# Access Compliance Report

## Public Rights-of-Way

### (Curb Ramps)

Intersection ID: 45174	Main Street: LINDEN_TREE_LN	Cross Street: SOCIETY_ST	Location: NW
ADA ID: 87F7AFA0C15D	Ramp Type: Perp	Initial Pass/Fail: Fail	Overall Compliance: No
Severity Score: 12.5			
Codes/Mitigation Info/Possible Solution		Field Measurements/Component Compliance

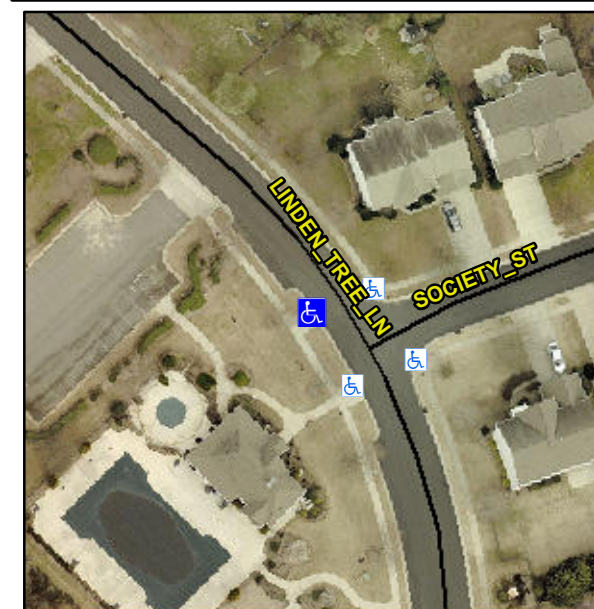
**Not Found, R304.2.2**

Compliance	Description	Data	Compliance	Description	Data
N/A	Ramp Length (in)	122.0	No	Ramp Slope (%)	9.4
Yes	Ramp Width (in)	60.0	Yes	Ramp XSlope (%)	0.6
N/A	Flare Type LT	N/A	N/A	Flare Type RT	N/A
N/A	Flare Slope LT (%)	N/A	N/A	Flare Slope RT (%)	N/A
N/A	Flare Traversable LT?	N/A	N/A	Flare Traversable RT?	N/A
N/A	Landing Length (in)	N/A	N/A	DWS Provided?	N/A
N/A	Landing Width (in)	N/A	N/A	DWS Contrast?	N/A
N/A	Landing Slope (%)	N/A	N/A	DWS Length (in)	N/A
N/A	Landing X Slope (%)	N/A	N/A	DWS Full Width?	N/A
N/A	Landing Curb? (Y/N)	N/A	N/A	DWS Offset (in)	N/A
N/A	Shared Landing?	N/A			
N/A	Gutter Ponding?	N/A	N/A	Gutter Slope (%)	N/A
N/A	Gutter Lip Ht (in)	N/A	N/A	Gutter X Slope (%)	N/A
N/A	Painted X Walk1?	No	N/A	Painted X Walk2?	N/A
	X Walk 1 Direction	To NE		X Walk 2 Direction	N/A
N/A	X Walk 1 Width (in)	N/A	N/A	X Walk 2 Width (in)	N/A
	X Walk 1 Slope (%)	2.3		X Walk 2 Slope (%)	N/A
	X Walk 1 X Slope (%)	2.4		X Walk 2 X Slope (%)	N/A

**Remove & Replace Entire Ramp.**
